TOWN OF BROOKLYN PLANNING AND ZONING COMMISSION PUBLIC HEARING LEGAL NOTICE

SP 20-002 Special Permit for additional vehicle storage, Applicant: Vachon Brooklyn, LLC, 512 Providence Road, Proposed construction of two 16 ft. wide access drives to proposed new vehicle storage lots.

ENGINEERING PLAN REVIEW
PERTAINING TO
PROPOSED PARKING EXPANSION
VACHON CHEVROLET
(Assessor's Map 41, Lots 13A & 14)
PROVIDENCE ROAD (ROUTE 6)
BROOKLYN, CT

The comments contained herein pertain to my review of plans, consisting of five sheets, entitled "Proposed Parking Expansion, 'Vachon Chevrolet', Providence Road (Route 6), Brooklyn, Connecticut, Prepared for Vachon Brooklyn, LLC.," prepared by Killingly Engineering Associates, dated January 2020 with revision date of March 10, 2020.

SHEET 3 OF 5 - SITE DEVELOPMENT PLAN NO. 1

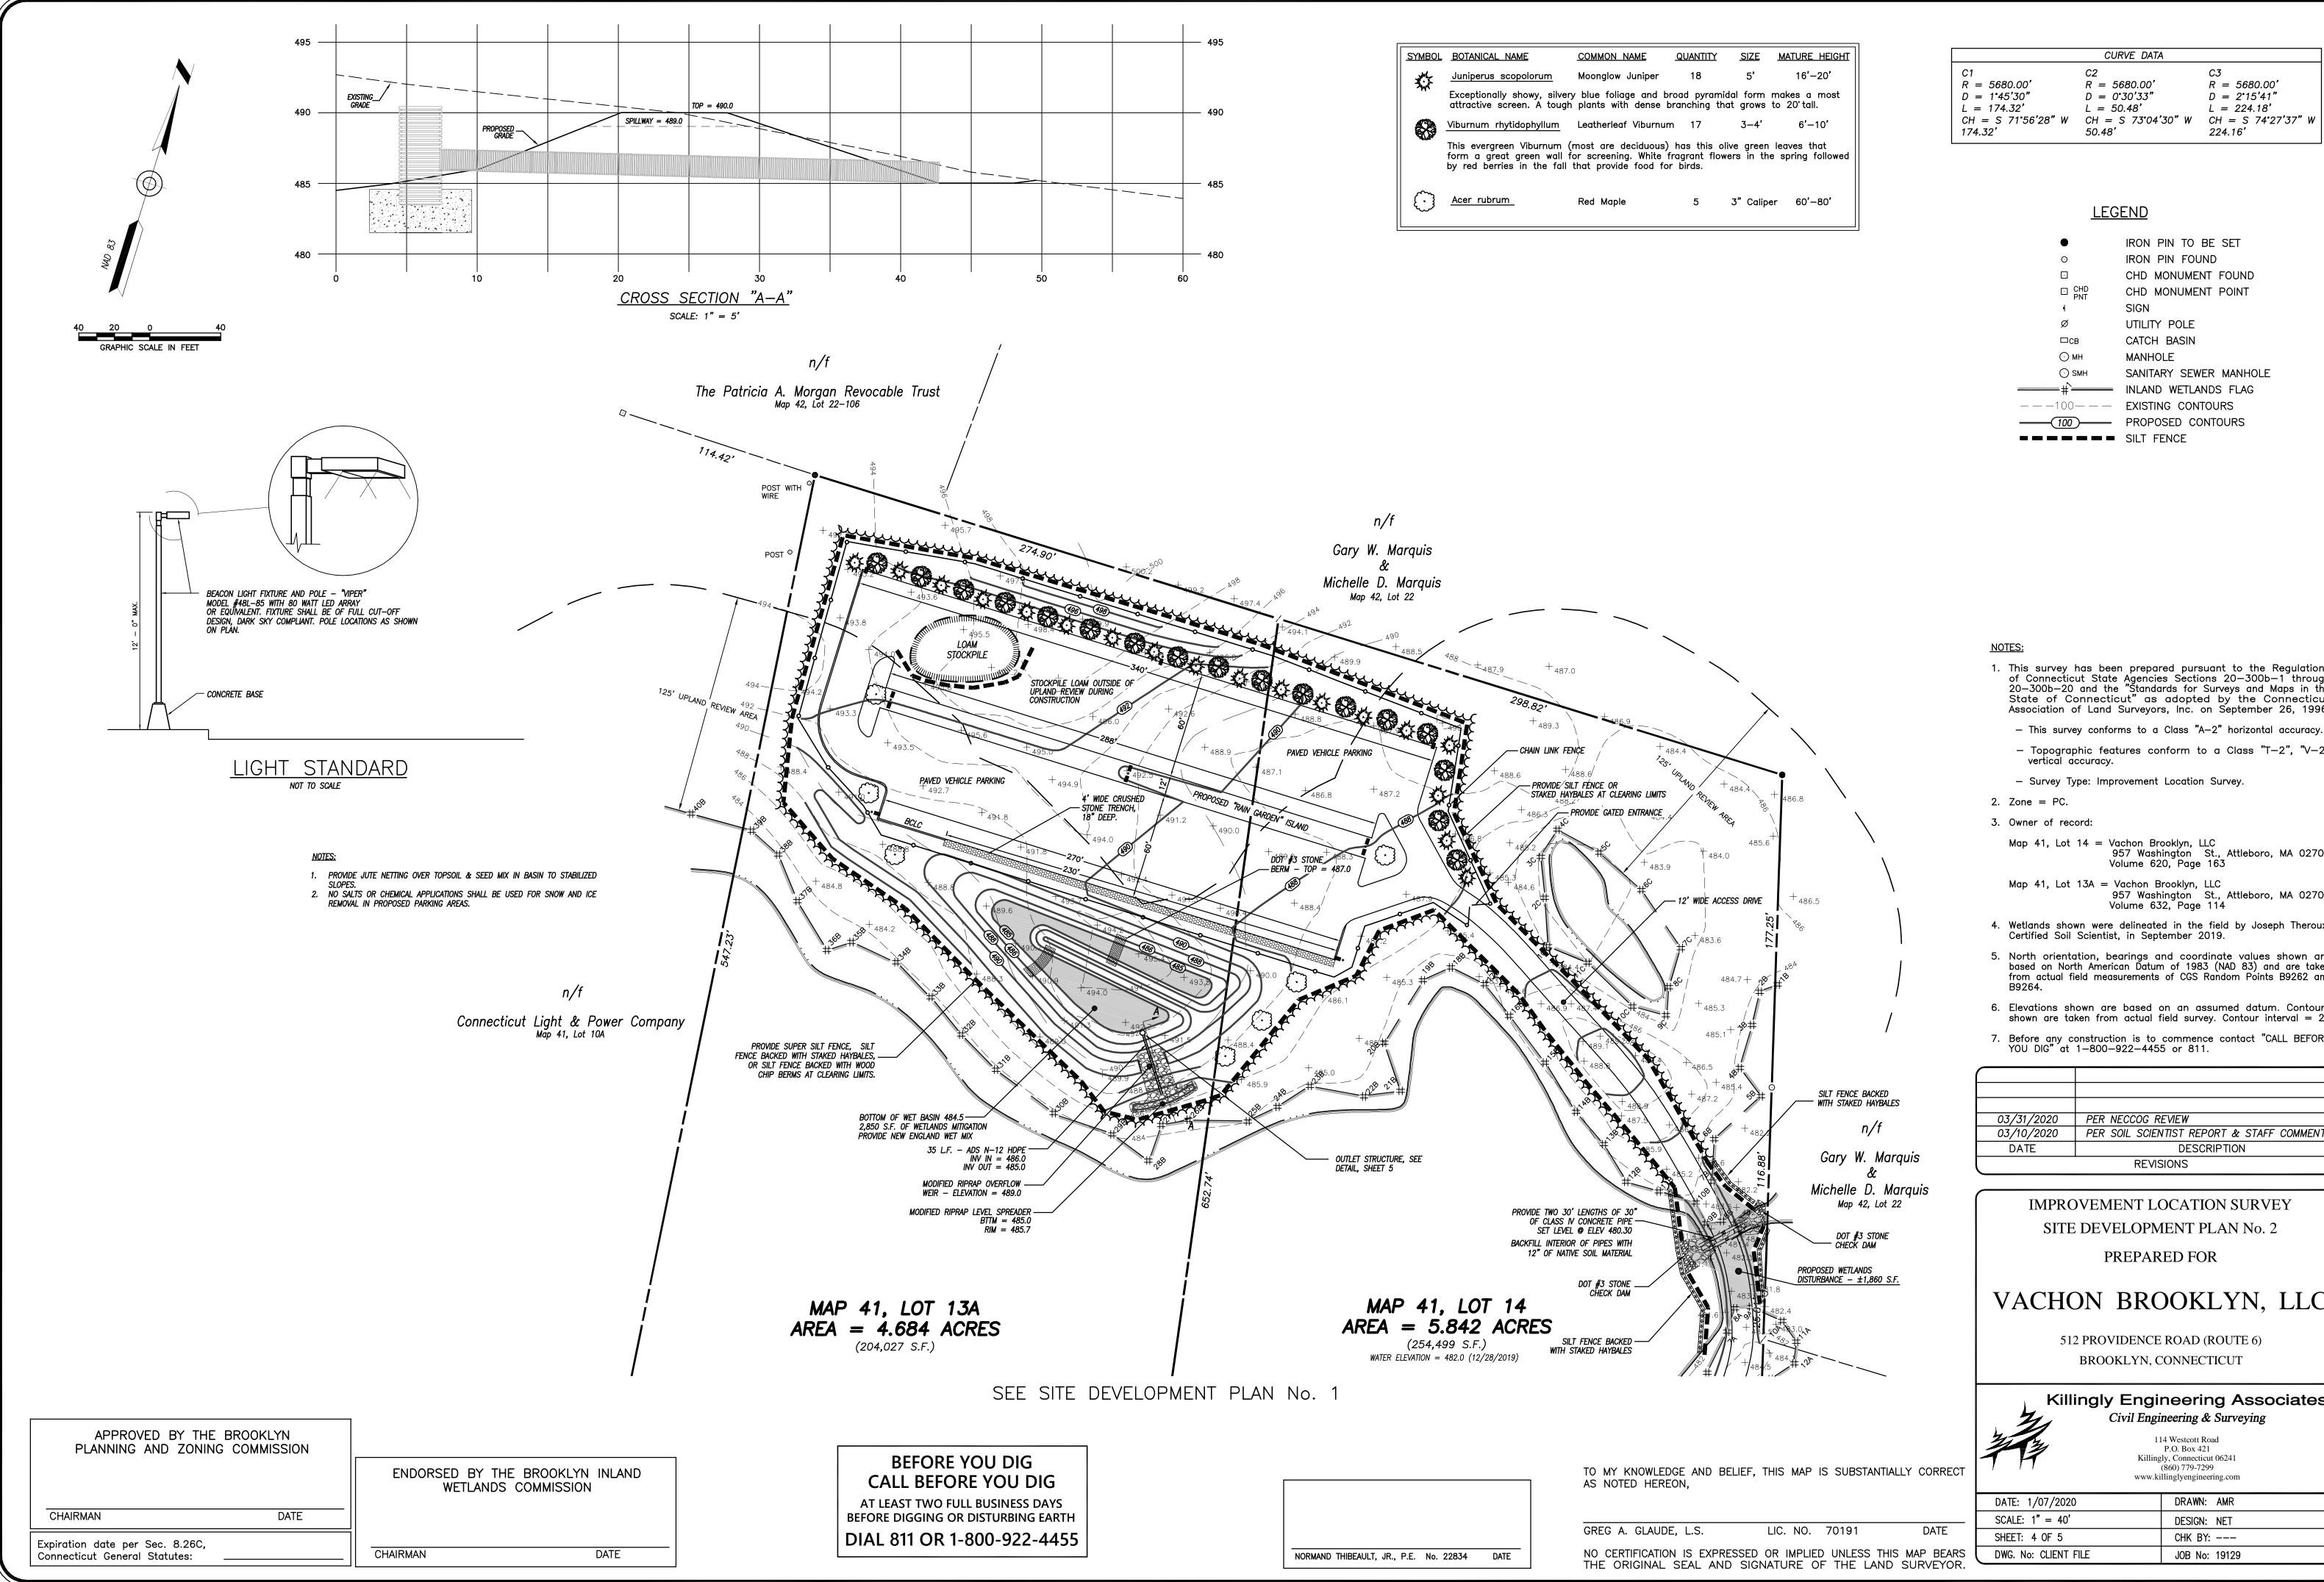
- A construction entrance symbol is drawn at the entrance to the new "paved vehicle storage area."
 However, a note should be included to indicate that this will be removed at the time the first course
 of paving is installed for the vehicle storage area. Additionally, it would be helpful for this
 explanation to be included in Note 17 under "Development Schedule/Sequence of Operations" that
 appears on Sheet 5 of 5 of the plan set.
- 2. The note "Silt Fence Backed with Staked Haybales or Wood Chip Berms" should read the same as the note on Sheet 4 of 5, "Provide Super Silt Fence, Silt Fence Backed with Staked Haybales, or Silt Fence Backed with Wood Chip Berms at Clearing Limits." for consistency.

Sheet 3 of 5 – Site Development Plan No. 1

- 1. A note has been added to the plan to direct the contractor to remove the anti-tracking construction entrance prior to installing the first course of payement. This has also been noted on sheet 5 of 5 in the development schedule/sequence of operations.
- 2. The note "silt fence backed with staked haybales or wood chip berms" has been modified to read the same on all sheets.

SHEET 5 OF 5 - DETAIL SHEET

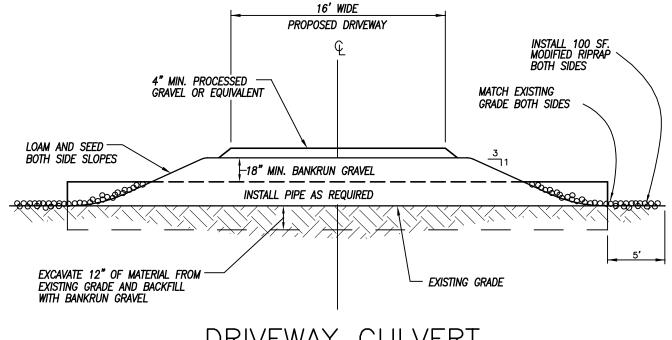
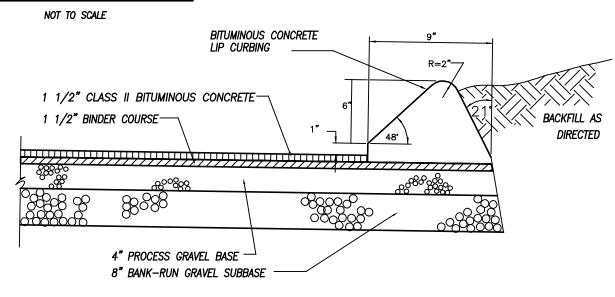
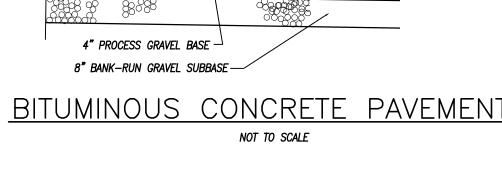
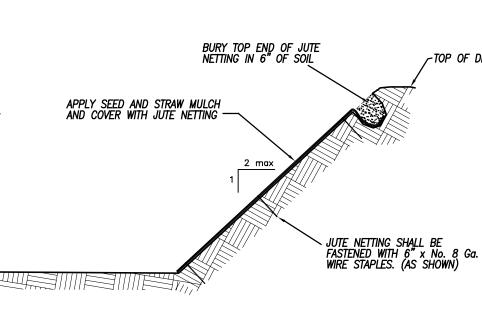
- In the "Stormwater Basin Outlet Detail," a smooth outer wall PVC pipe may be less susceptible to upheaval or degradation (breakage) by icing conditions than a corrugated type of pipe. It is recommended that this be evaluated by the designer. Furthermore, over time, ultraviolet rays in sunlight degrades unprotected plastic pipe, which causes it to lose structural integrity and stability. Considering this, concrete may be a better choice.

- 2. In the "Stone Berm" detail, what specific type of filter fabric should be used to minimize sediment transport and at the same time allow the efficient transmission of water toward the outlet structure? This should be specified in the detail. Also, what are the conditions as to when the berm should be replaced to function as designed due to sediment build up?

- 3. It is recommended that the "Silt Fence Backed with Haybales" detail title be modified to read "Super Silt Fence (Silt Fence Backed with Haybales or Wood Chip Berms)."

- 4. In the "Chain Link Fence Detail" the gauge of the fence fabric and size of the selvage should be specified and also what type of material it is manufactured from (galvanized steel, PVC coated steel, etc.). The same goes for the posts and hardware, too, and depth of bury/concrete anchorage for the posts.

- 5. In the "Stone Berm" detail, will CONNDOT crushed stone M.01.01 #3 remain stable at a 2:1 angle of repose?
- 6. In the "Slope Stabilization Detail" it is recommended that the slope be 3:1 or flatter, NOT 2:1 or steeper, as shown.

- 7. In the "Bituminous Lip Curb" detail it is recommended that the curb be formed on the binder course (locked in) for better stability/longevity, which should provide more resistance to deformation by snowplowing operations or other vehicle impacts.

- 2. For the stone berm, specifications for the filter fabric have been called out and conditions for maintenance are defined.
- 3. The silt fence detail has been modified to read "super silt fence" as requested.

- 4. The detail for the fence installation has been modified as requested. In addition, neighbors who attended the public hearing for wetlands requested an 8' fence in lieu of a 6' fence which has been accommodated.

- 6. We have modified the slope stabilization detail to call for application on slopes 2:1 or flatter per 5-4-10 of the 2002 Guidelines.
- 7. Bituminous curb installation detail has been modified accordingly as requested.
